CITY OF KELOWNA

MEMORANDUM

Date: March 23, 2020
File No.: Z20-0021
To: Suburban and Rural Planning (AK)
From: Development Engineering Manager (JK)
Subject: 2980 Gallagher Rd - Kirschner Mountain Phase 6 – A1 to RH3

WORKS AND SERVICES REQUIREMENTS

SITE PLAN

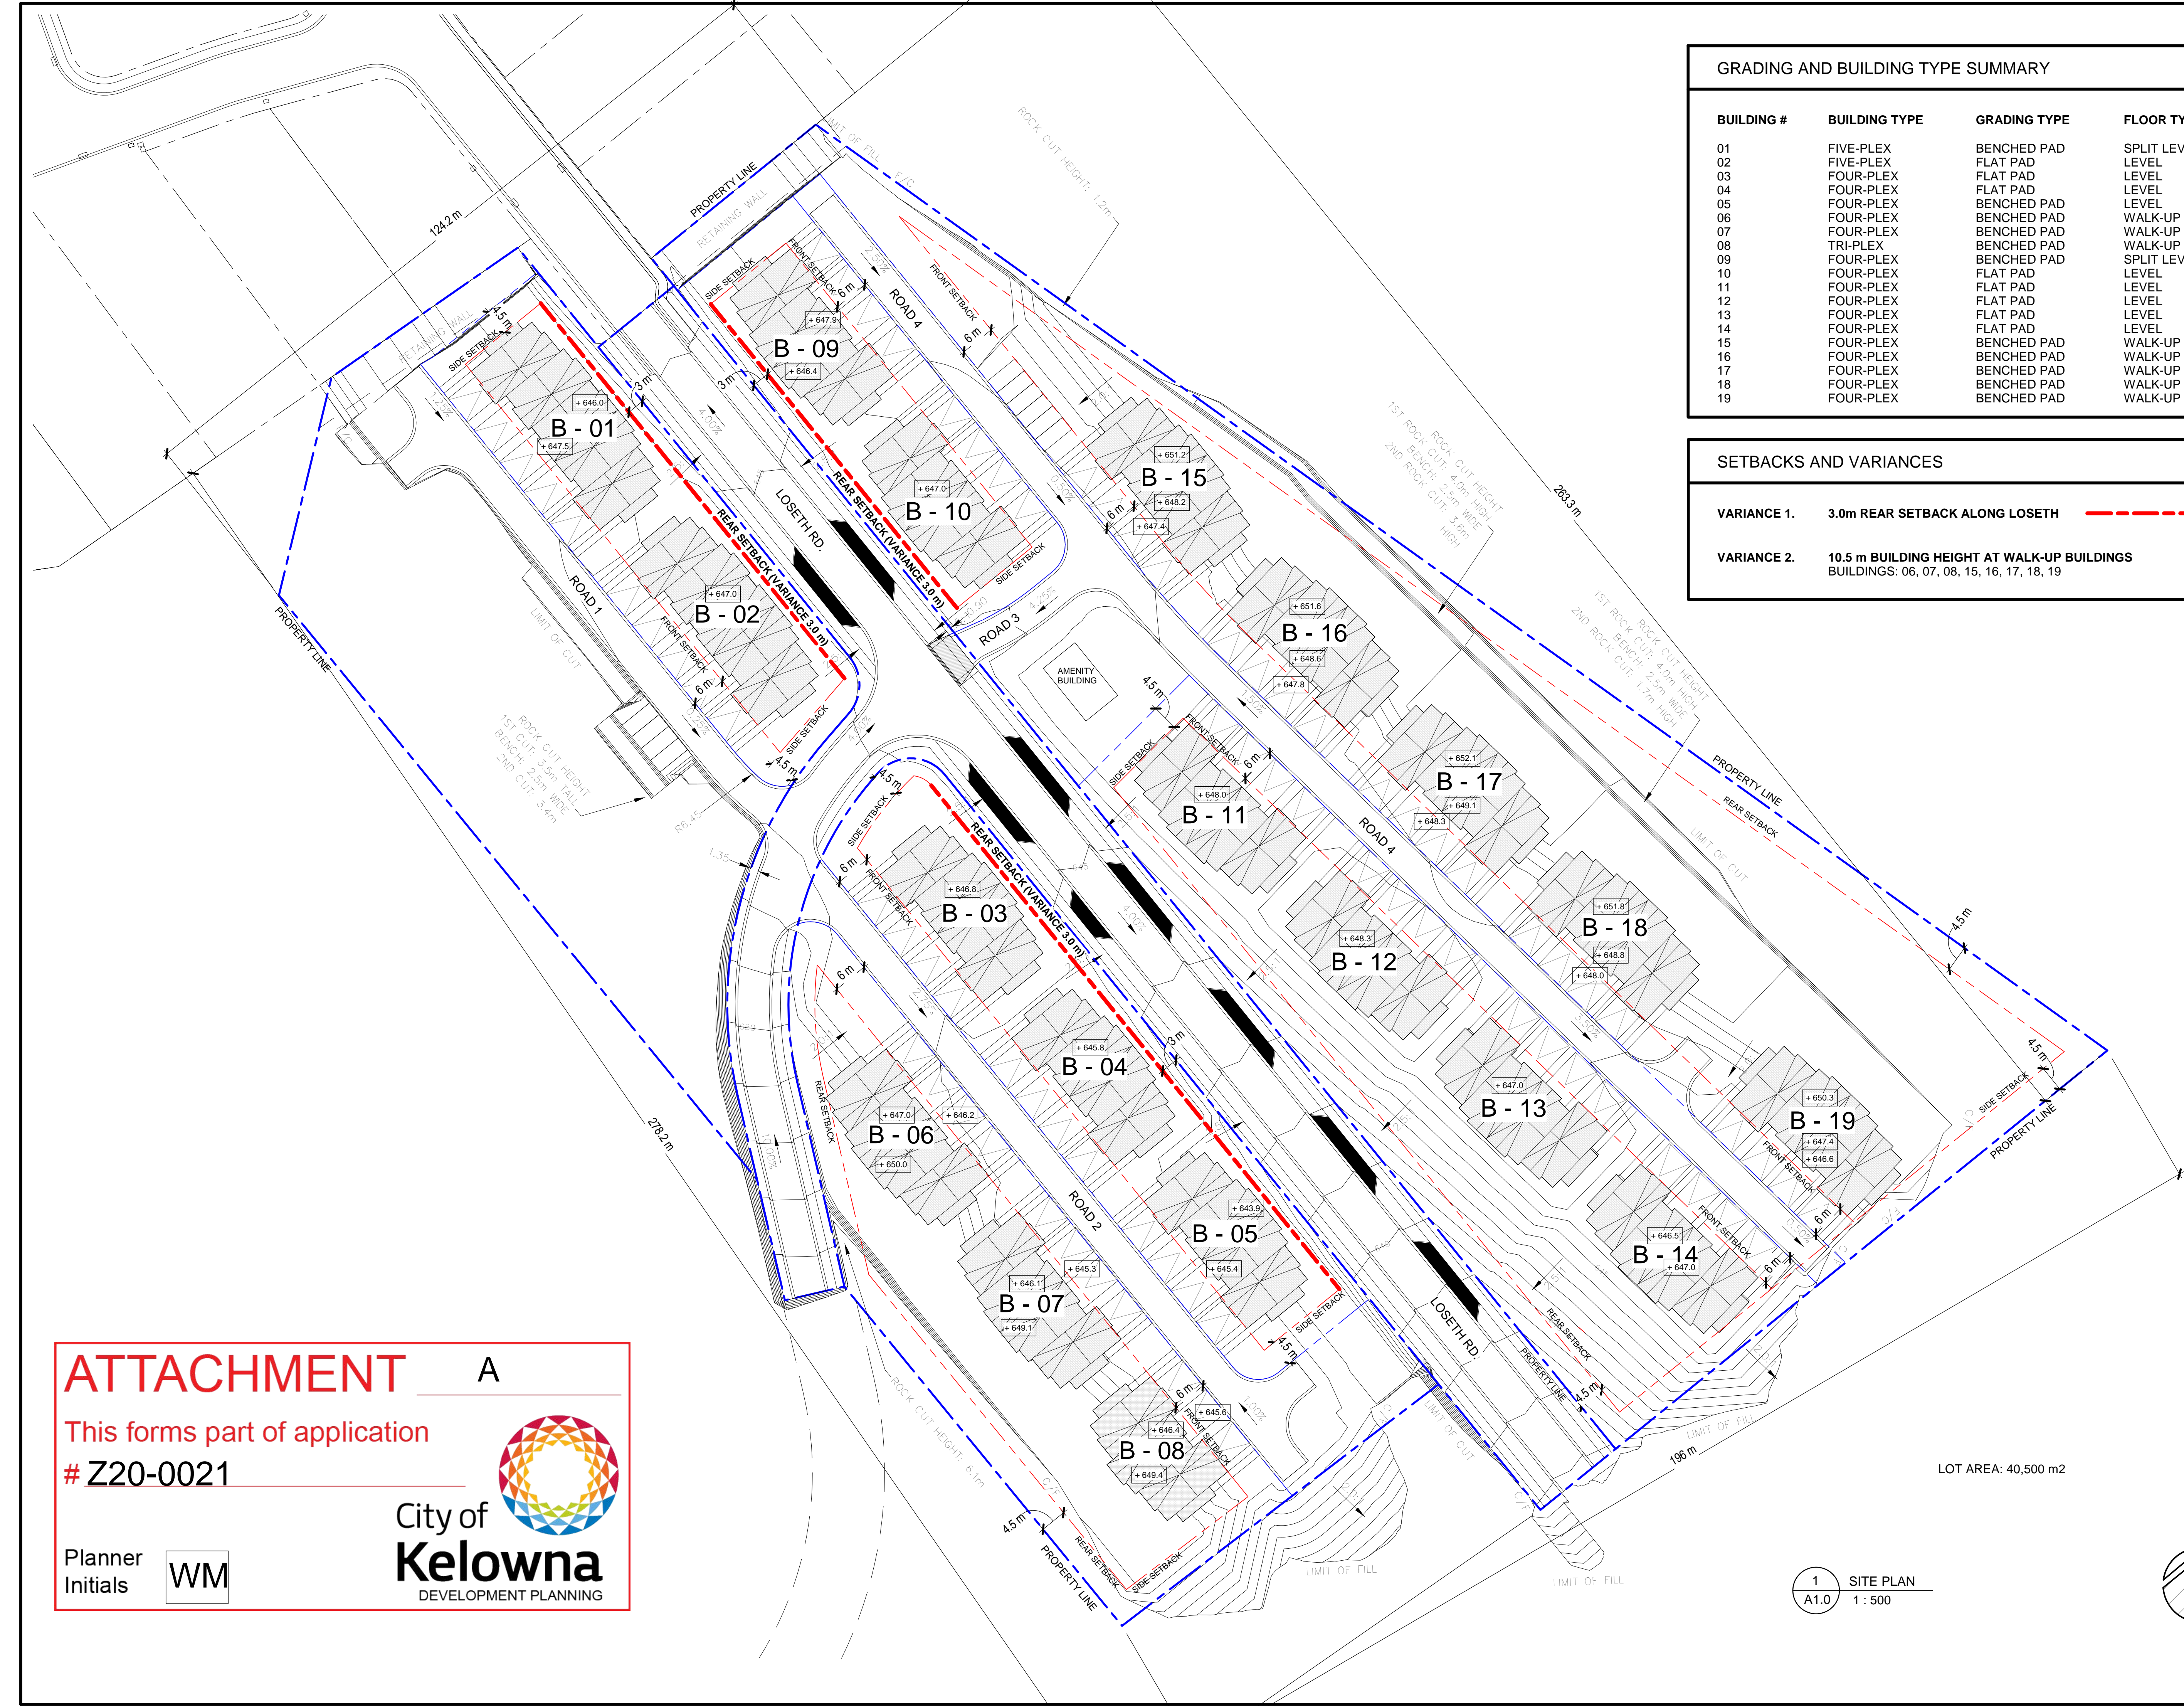
- a) All retaining walls are to be contained within privately-owned lots.
- b) As Loseth Rd is classified as a Major Collector, waste collection vehicles cannot back onto Loseth Rd. Please provide on-site turning movements showing an MSU vehicle turning on site without having to back onto Loseth Rd.

- a) Clarify the proposed legal protections (e.g., no-build/no-disturb covenants) for the 2H:1V fill slopes outside of the proposed property lines.
